Staff Report & Recommendation

Design Review Board

SUBJECT: DRB23-0928

600-650 72nd Street, 7116-7134 Carlyle Avenue, 7121 Dickens Avenue and 601-621 71st Street.

Figure 1 Valet Parking Route

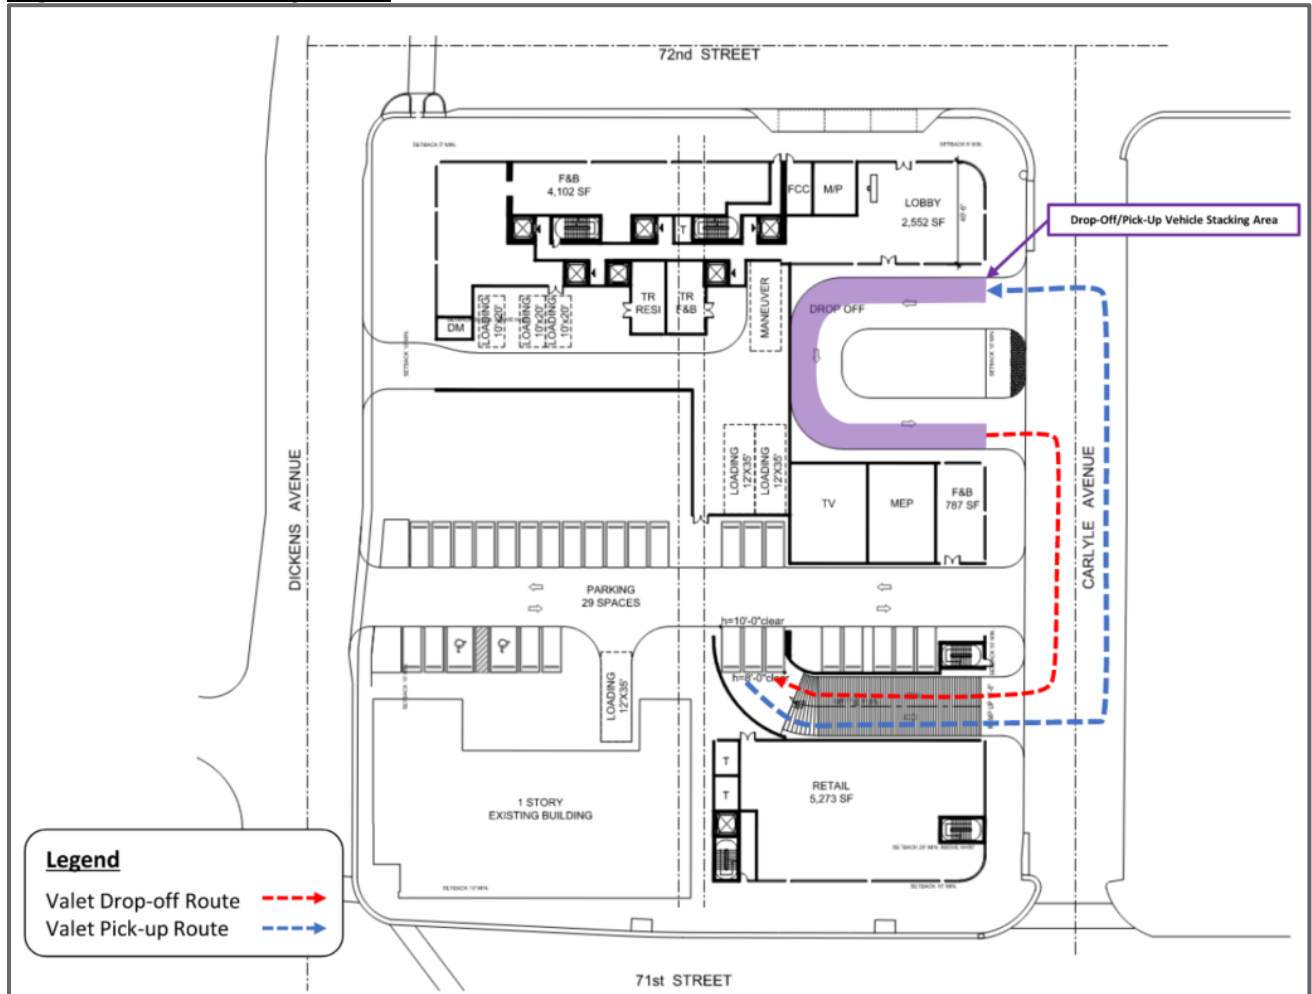
The valet drop-off/pick-up area consists of one (1) valet drop-off/pick-up lane with storage for approximately seven (7) vehicles. Valet operations analysis demonstrates that a maximum of one (1) valet attendant would be required at the valet drop-off/pick-up area to not exceed the vehicle drop-off/pick-up storage during peak times. The valet queuing operations analysis was performed based on the methodology outlined in Institute of Transportation Engineers' (ITE's) *Transportation and Land Development*, 1988. The project is to provide a sufficient number of valet attendants to ensure that the queue from the valet does not extend onto public right-of-way. The proposed valet is for residents only and is proposed to operate under market conditions. Only a small portion during the AM and PM peak hours of residential trips will be valeted and all of the retail trips will

be self-park.

- g. The applicant shall commit to provide the sufficient number of valet attendants for residents only to ensure that the queue from the valet does not extend onto public right-of-way, a minimum of one (1) attendant during normal peak periods.
